Monitoring Report – MY3
FINAL VERSION
Lake Wendell Mitigation Project
Calendar Year of Data Collection: 2020

NCDEQ DMS Project Identification # 97081
NCDEQ DMS Contract # 6826
Neuse River Basin (Cataloging Unit 03020201)
USACE Action ID Number: SAW-2016-00876
NCDEQ DWR Project # 2016-0385
Johnston County, NC
Contracted Under RFP # 16-006477
Data Collection Period: September-October 2020
Submission Date: December 11, 2020

RE: WLS Responses to NCDEQ DMS Review Comments for Task 9 Draft Monitoring Report Year 3 for the Lake Wendell Mitigation Project, NCDEQ DMS Full-Delivery Project ID #97081, Contract #6826, Neuse River Basin, Cataloging Unit 03020201, Johnston County, NC

Figure 5: Monthly Rainfall Data
Lake Wendell Mitigation Project (NCDEQ DMS Project ID# 97081)
MY3 2020

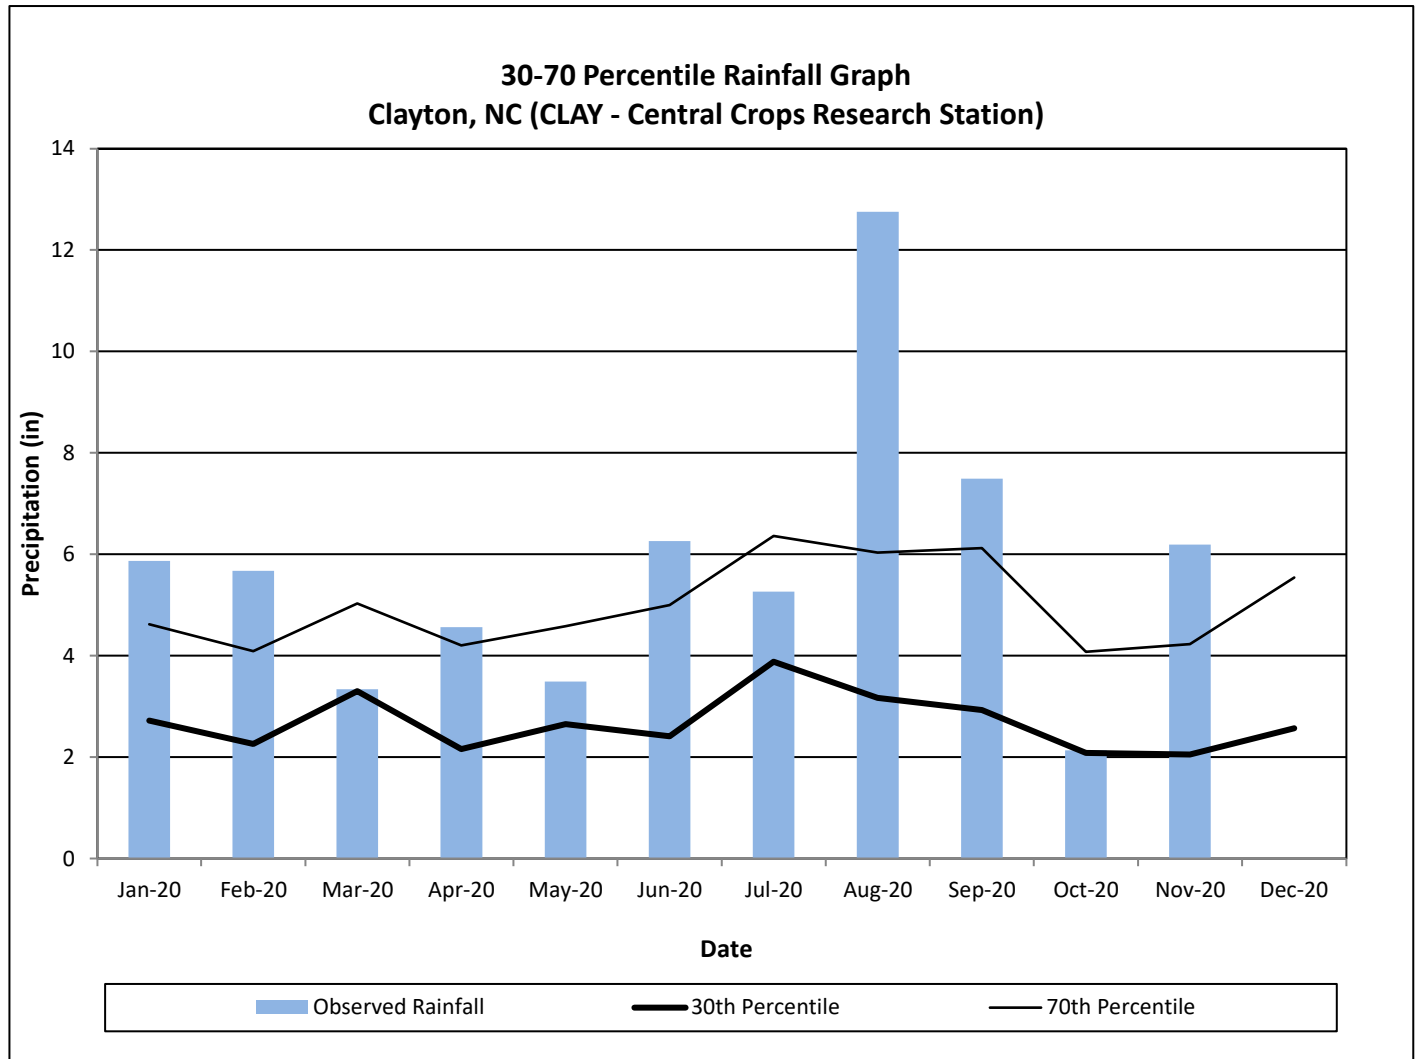
- 2. DMS Comment: Update rain report for October and November if possible.** WLS Response: WLS updated Figure 5 with the October and November rain total.
